STAFF REPORT

COMMUNITY DEVELOPMENT DEPARTMENT

Final Plat consisting of 30 residential building lots and nine (9) common lots on approximately 3.79 acres of land in the R-40 zoning district by Breckon Land Design on behalf of LH Development, LLC.

B. Final Plat (dated: 07/02/24)

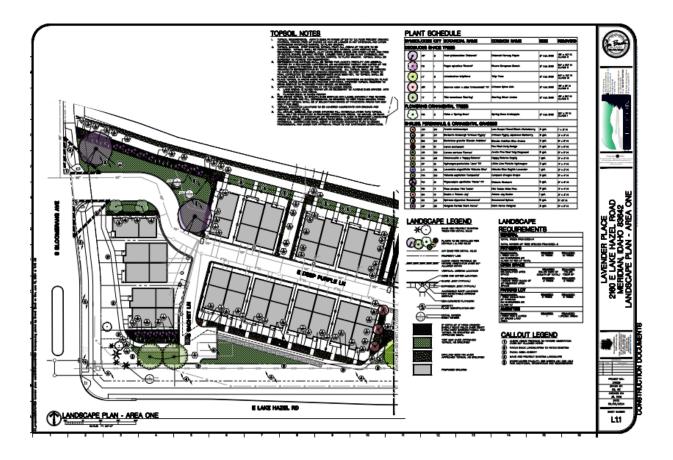
- 3. Prior to submittal for the City Engineer's signature, have the Certificate of Owners and the accompanying acknowledgment signed and notarized.
- 4. The final plat prepared by Land Solutions, dated: 07/02/2024, included in Section V.B shall be revised as follows:

- a. Note #3: Include the recorded instrument number for the ACHD license agreement.
 - b. Note #7: Shall be revised to include Lots 35-37, Block 1 in the common drive language.

- c. Note #12: Include the recorded instrument number of the City of Meridian Pathway Easement.
 - d. Add a plat note stating that direct lot access to E. Lake Hazel Road is prohibited.

- e. Lot 6, Block 1 shall be widened to 20 feet to accommodate for the sewer easement.

A copy of the revised plat shall be submitted with the final plat for City Engineer signature.

C. Landscape Plan ((dated: 4/11/2024)

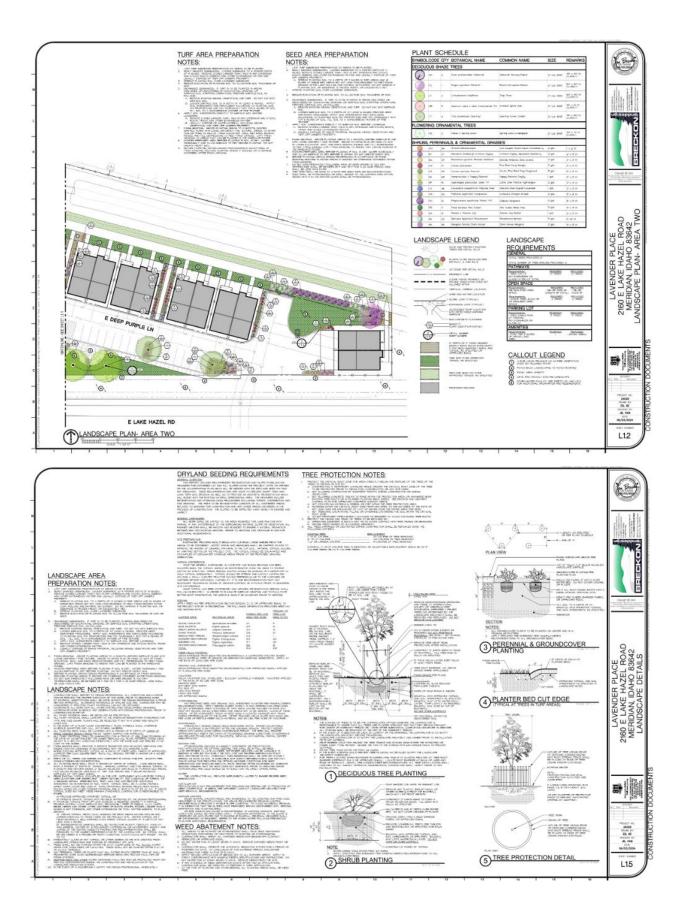
- 5. The landscape plan prepared by Breckon Land Design, dated 06/03/2024, included in Section V.C, shall be revised as follows:
 - a. Provide fencing details for all fencing.
 - b. Provide a tree every 100 linear feet along the multi-use pathway along the north boundary of the property.
 - c. Provide a tree in each of the planter islands for the parking on the east end of the common drive.

A copy of the revised plat shall be submitted with the final plat for City Engineer signature.
